## QUALITY ASSURANCE -- NON-CONFORMANCE REPORT

**Report No:** NCR-000130

**Reference Description:** Repairs to Base Metal

**Job Name:** SAS Superstructure

项目名称 Project Name	美国海湾大桥 SFOBB	部件图号 Drawing No	SEG15A	报告编号 Report No.	B-CWR086
合同号 Contract No.:	04-0120F4	部件名称 Items Name	BP9A	NDT报告编号 Report No.of NDT	
项目编号 Project No.:	ZP06-787

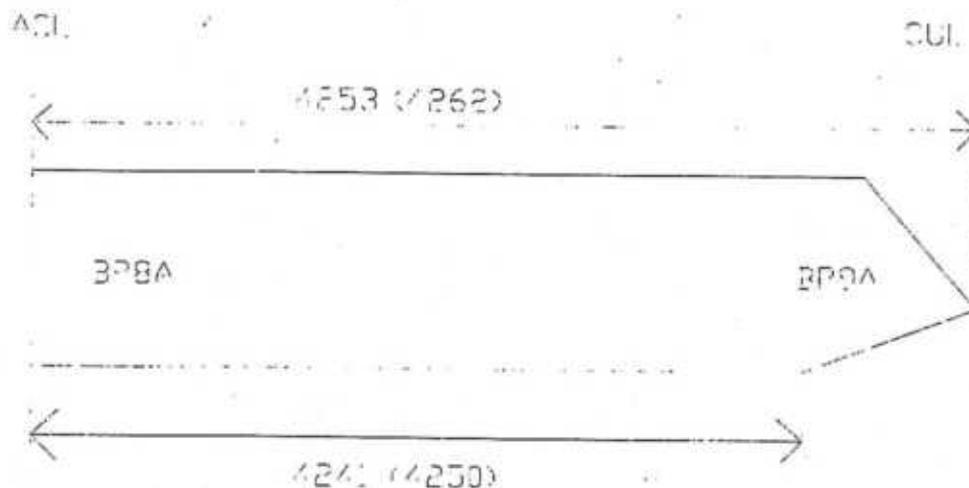
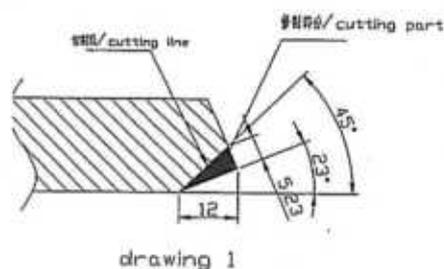
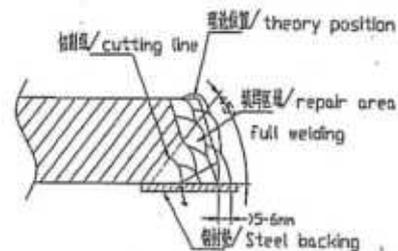
胡同兴施工队制作的西线3B节段D6型底板BP9A, 如下图所示ACL控制线到余量修割线为4250mm、4262mm。由于切割错误导致多切割9mm, 实际测量为4241mm、4253mm。

When fabrication West 3B segment type D6 bottom BP9A, per error cutting, it should be 4250mm and 4260mm from Assembly Control Line (ACL) to Cut Line (CUL), but it is only 4241mm and 4253mm.

Due to cutting operator careless causing the residue cutting error.

1. 沿着图一所示切割线将母材下半部分割除;
2. 准备一个正确的接头形式, 具体参照相应的WPS;
3. 对修补区域进行VT/MT检测;
4. 按照图二所示加钢衬垫, 具体要求参见AWS D1.5.3.13;
5. 根据返修的焊接返修工艺规程(WPS)进行预热及焊接, 焊后尺寸要比实际尺寸大5-6mm;
6. 去除钢衬垫, 将修补焊缝打磨至与周围母材平齐;
7. 对返修区域做NDT (MT UT) 以保证金属融合的深度;
8. 按照图纸要求重新开制坡口。

1. Trim the bellow part of the metal along cutting line (for drawing 1) according to the attached drawing and grind the cutting line smoothly;
2. Prepare excavation according to the relevant WPS;
3. Verify with VT/MT repair area is free of all defects.
4. Add steel backing according to the attached drawing 2 (refer to AWS D1.5.3.13);
5. Preheat and weld according to the relevant WPS and dimension of lineament is more than 5-6mm necessary actual dimension;
6. Remove the steel backing and grind the weld flush with around metal;
7. Perform post NDT (VT MT UT) of repaired area to insure sound weld metal has been deposited.
8. Prepare an groove again according to the shop drawings

项目名称 Project Name	美国海湾大桥 SFOBB	部件图号 Drawing No	SEG15A	报告编号 Report No.	B-WR337
合同号 Contract No.:	04-0120F4	部件名称 Items Name	BP9A	NDT报告编号 Report No.of NDT	
项目编号 Project No.:	ZP06-787

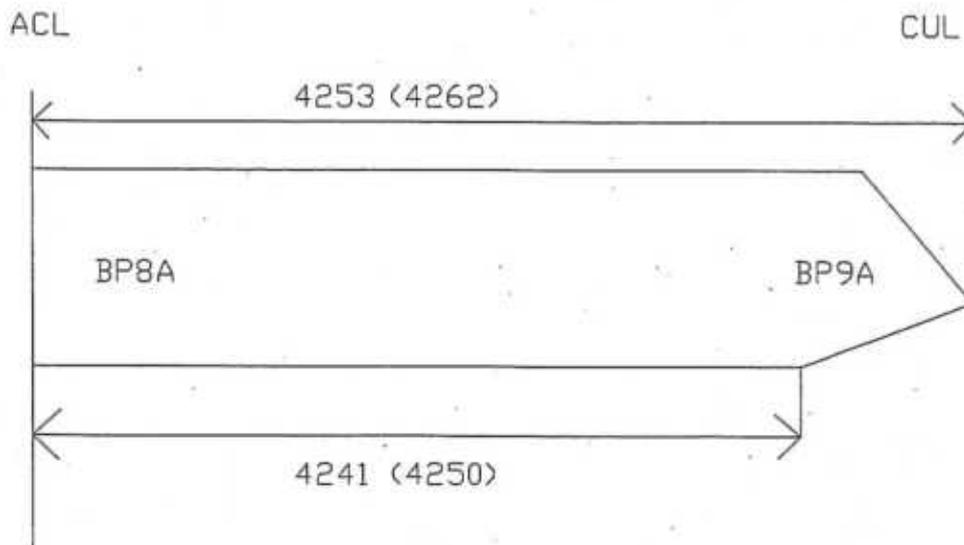
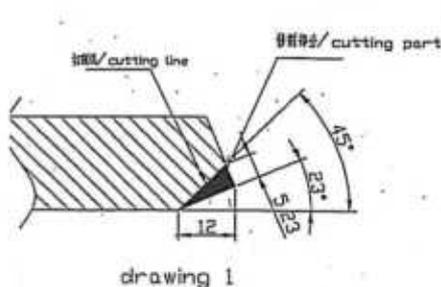
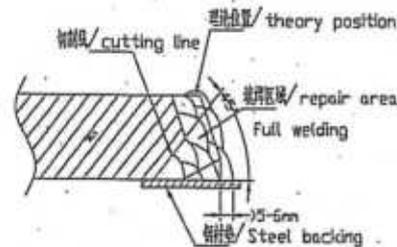
胡国兴施工队制作的西线3B节段D6型底板BP9A, 如下图所示ACL控制线到余量修割线为4250mm、4262mm, 由于切割错误导致多切割9mm, 实际测量为4241mm、4253mm。

When fabrication West 3B segment type D6 bottom BP9A, per error cutting, it should be 4250mm and 4260mm from Assembly Control Line (ACL) to Cut Line (CUL), but it is only 4241mm and 4253mm.

Due to cutting operator careless causing the residue cutting error.

1. 沿着图一所示切割线将母材下半部分割除;
2. 准备一个正确的接头形式, 具体参照相应的WPS;
3. 对修补区域进行VT/MT检测;
4. 按照图二所示加钢衬垫, 具体要求参见AWS D1.5.3.13;
5. 根据返修的焊接返修工艺规程(WPS)进行预热及焊接, 焊后尺寸要比实际尺寸大5-6mm;
6. 去除钢衬垫, 将修补焊缝打磨至与周围母材平齐;
7. 对返修区域做NDT (MT UT) 以保证金属融合的深度;
8. 按照图纸要求重新开制坡口。

1. Trim the bellow part of the metal along cutting line (for drawing 1) according to the attached drawing and grind the cutting line smoothly;
2. Prepare excavation according to the relevant WPS;
3. Verify with VT/MT repair area is free of all defects.
4. Add steel backing according to the attached drawing 2 (refer to AWS D1.5.3.13);
5. Preheat and weld according to the relevant WPS and dimension of lineament is more than 5-6mm necessary actual dimension;
6. Remove the steel backing and grind the weld flush with around metal;
7. Perform post NDT (VT MT UT) of repaired area to insure sound weld metal has been deposited.
8. Prepare an groove again according to the shop drawings

项目名称 Project Name	美国海湾大桥 SFOBB	部件图号 Drawing No	SEG15A	报告编号 Report No.	B-WR337
合同号 Contract No.:	04-0120F4	部件名称 Items Name	BP9A	NDT报告编号 Report No. of NDT	
项目编号 Project No.:	ZP06-787

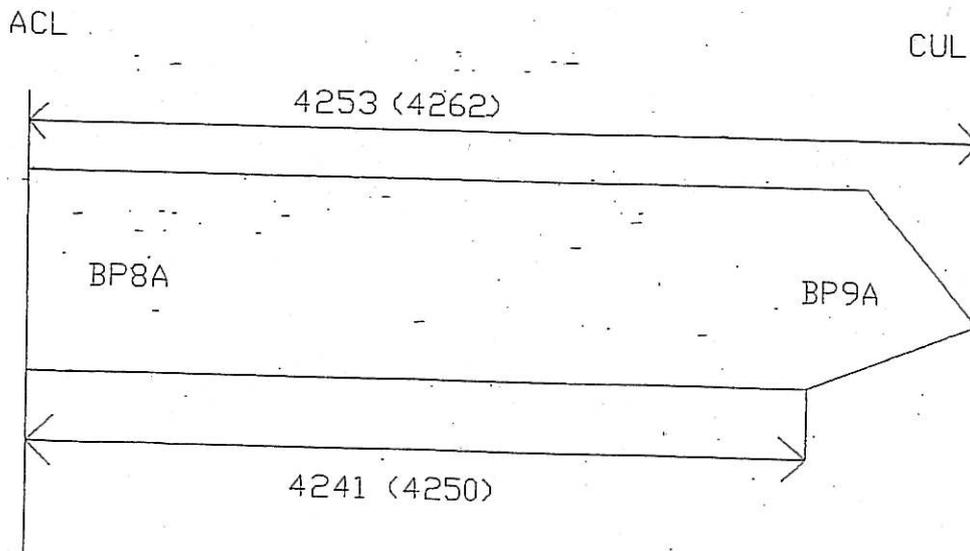
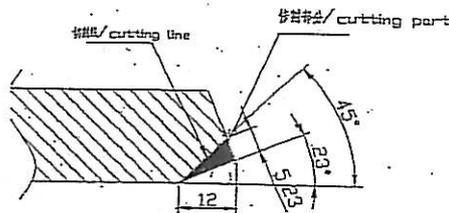
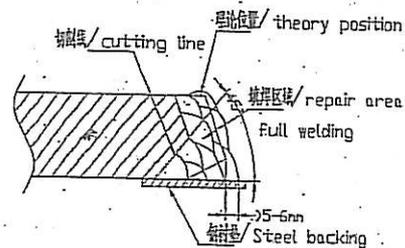
胡国兴施工队制作的西线3B节段D6型底板BP9A, 如下图所示ACL控制线到余量修割线为4250mm、2mm, 由于切割错误导致多切割9mm, 实际测量为4241mm、4253mm。  
When fabrication West 3B segment type D6 bottom BP9A, per error cutting, it should be 4250mm and 4260mm from Assembly Control Line (ACL) to Cut Line (CUL), but it is only 4241mm and 4253mm.

Due to cutting operator careless causing the residue cutting error.

1. 沿着图一所示切割线将母材下半部分割除;
2. 准备一个正确的接头形式, 具体参照相应的WPS;
3. 对修补区域进行VT/MT检测;
4. 按照图二所示加钢衬垫; 具体要求参见AWS D1.5.3.13;
5. 根据返修的焊接返修工艺规程(WPS)进行预热及焊接, 焊后尺寸要比实际尺寸大5-6mm;
6. 去除钢衬垫, 将修补焊缝打磨至与周围母材平齐;
7. 对返修区域做NDT (MT UT) 以保证金属融合的深度;
8. 按照图纸要求重新开制坡口。

1. Trim the bellow part of the metal along cutting line (for drawing 1) according to the attached drawing and grind the cutting line smoothly;
2. Prepare excavation according to the relevant WPS;
3. Verify with VT/MT repair area is free of all defects.
4. Add steel backing according to the attached drawing 2 (refer to AWS D1.5.3.13);
5. Preheat and weld according to the relevant WPS and dimension of lineament is more than 5-6mm necessary actual dimension;
6. Remove the steel backing and grind the weld flush with around metal;
7. Perform post NDT (VT MT UT) of repaired area to insure sound weld metal has been deposited.
8. Prepare an groove again according to the shop drawings
